City of Kingston Planning Committee Meeting Number 19-2020 Addendum Thursday November 19, 2020 6:30 p.m., Electronic Meeting Format

a) Subject: Supplemental Report to Comprehensive Report Number PC-20-065 – Update to the Williamsville Main Street Study File Number: D35-003-2020 Address: Williamsville Main Street Application Type: Zoning By-Law Amendment Owner: Various Applicant: City of Kingston The Report of the Commissioner of Community Services (PC-20-070) is attached.

City of Kingston Report to Planning Committee Report Number PC-20-070

Figure 1: 12.5 metre tower separation from all property lines (Kmaps).

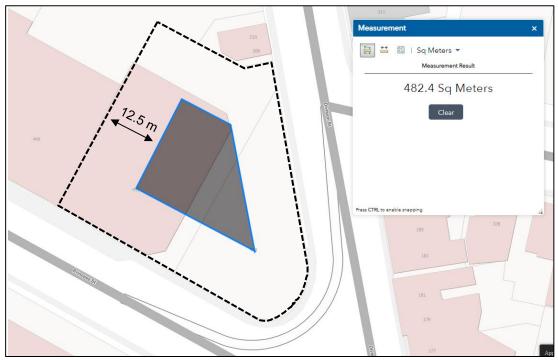
As illustrated below, a 12.5 m setback from adjacent properties on all lot lines reduces the potential tower floor plate to approximately 482 square metres whereas the by-law permits a maximum floor plate of 790 square metres. Based on discussions with the owner and our own experience on similar projects, a tower floor plate of this reduced size would not be viable. If the setback of 12.5 m applies to all property lines, our client requests that this be revised to apply only to those lot lines shared with developable properties and not street lines.
